NSW Independent  
Planning  
Commission

Pitt Street South  
OSD

INTERNAL AMENITY  
SUBMISSION

18 March 2021  
Final

SSDA Envelope Setbacks  
Metropolitan Fire Station / East

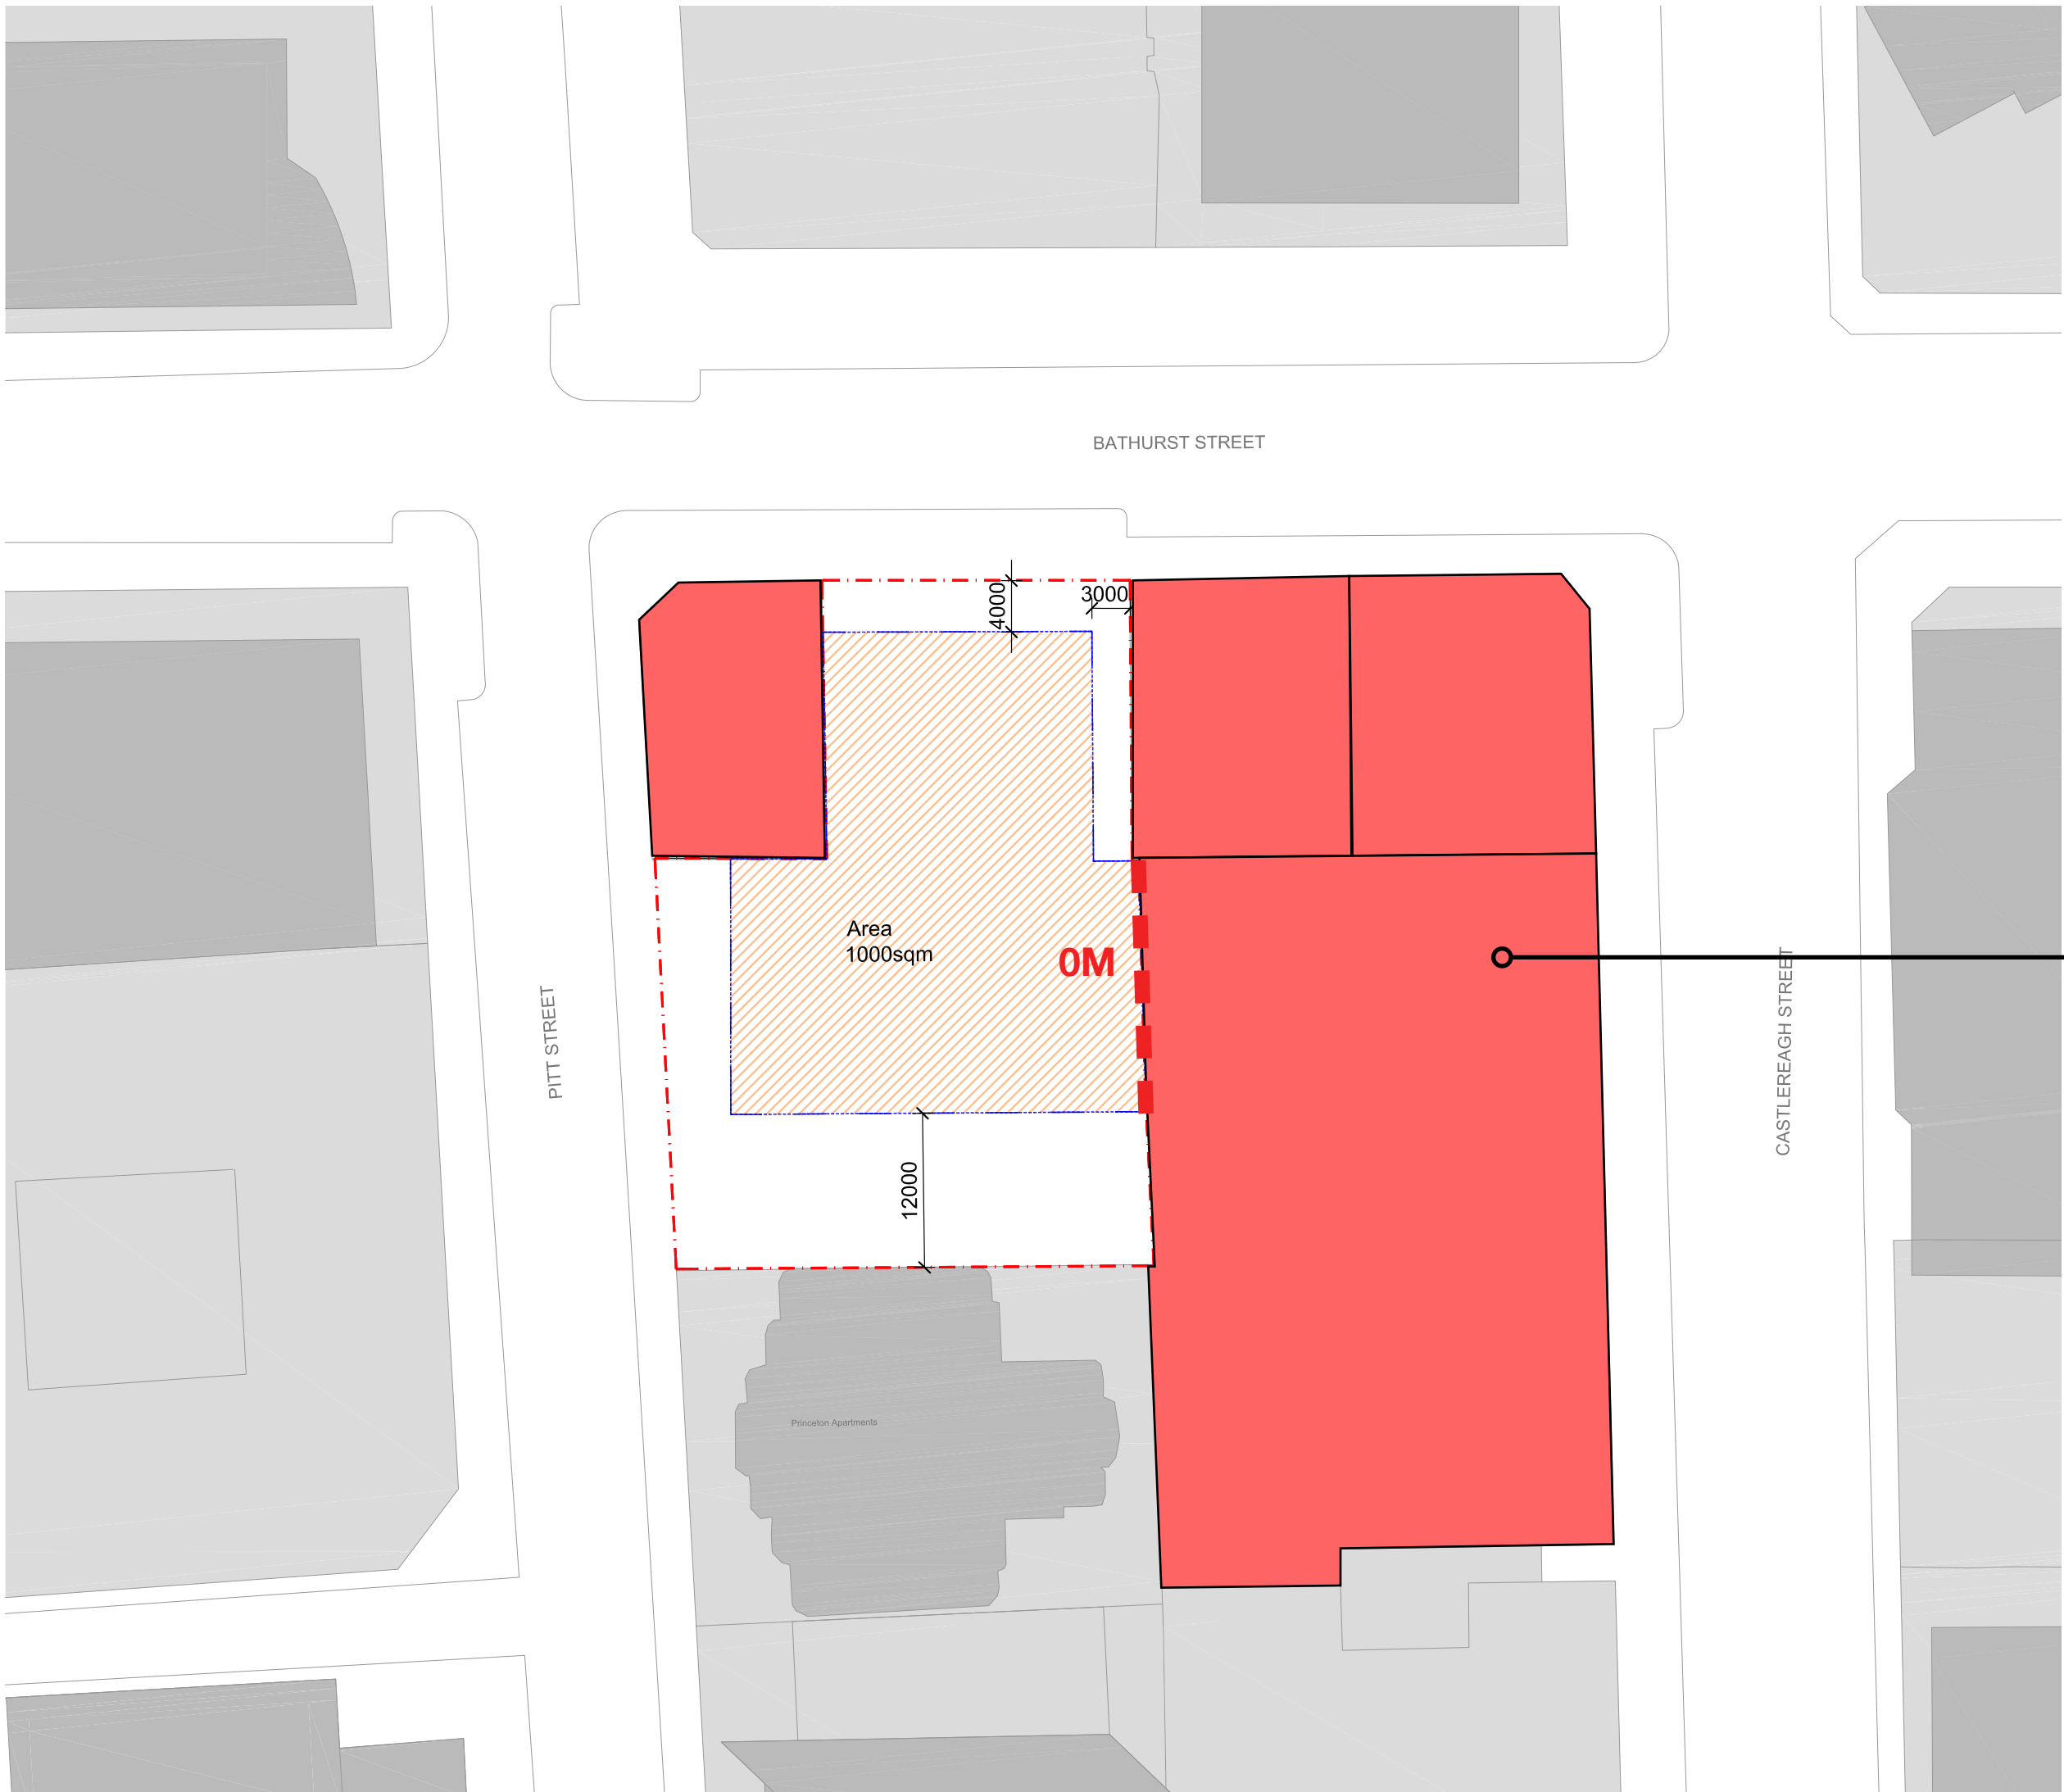
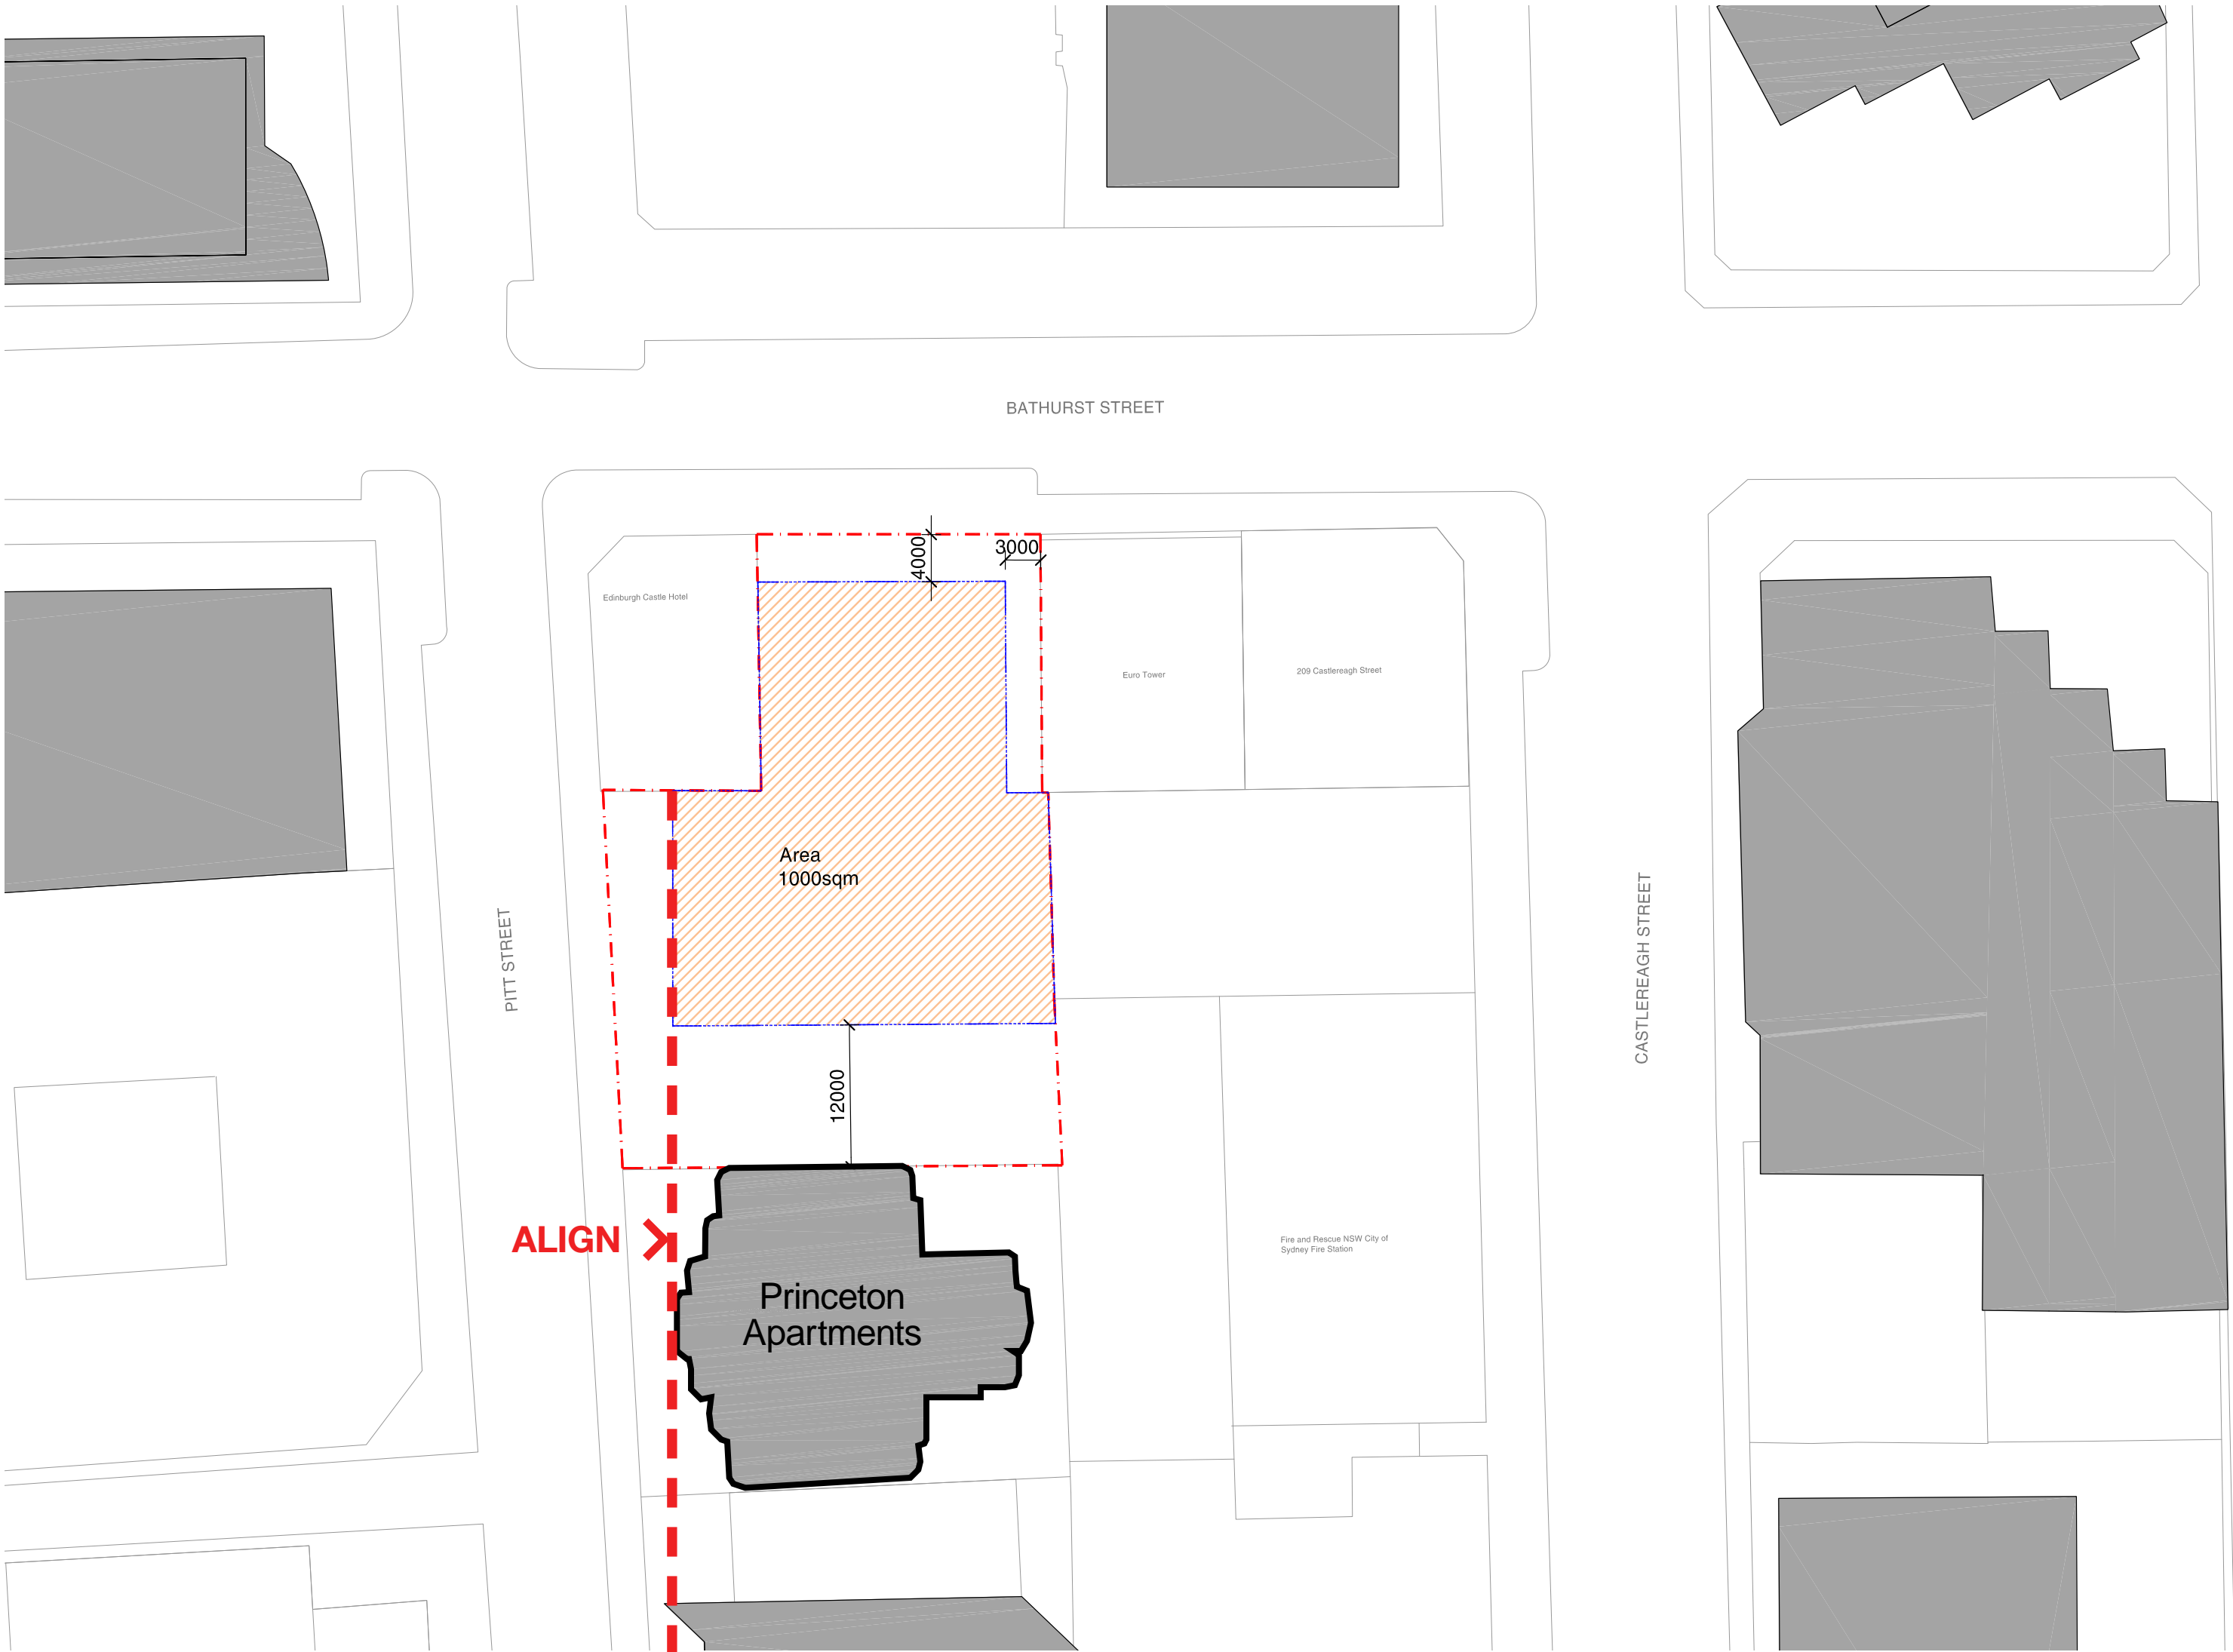
*The Panel raised concerns as to the significant challenges in choosing residential use on this site whilst also pursuing the maximum allowable envelope, noting that the concept design (SSDA) envelope does not distinguish between uses except regarding loading.*

*The design as presented does not satisfactorily achieve sufficient amenity to meet SEPP 65 ADG objectives. The scheme must demonstrate an approach to each boundary condition individually regarding the proposed use, specific conditions, controls and BCA compliance.*

### Response to DEEP Issue #1:

*We have thoroughly analysed the proposed design in relation to the SSDA envelope, BCA controls and and ADG requirements. The propsed design complies with the SSDA envelope setbacks. The design is also fully compliant with BCA light & ventilation requirements as well as BCA light and ventilation, building separation and visual privacy requirements. The proposed design also complies with ADG solar access and natural ventilation requirements, maximum number of apartments per floor and minimum apartment and private open space requirements.*
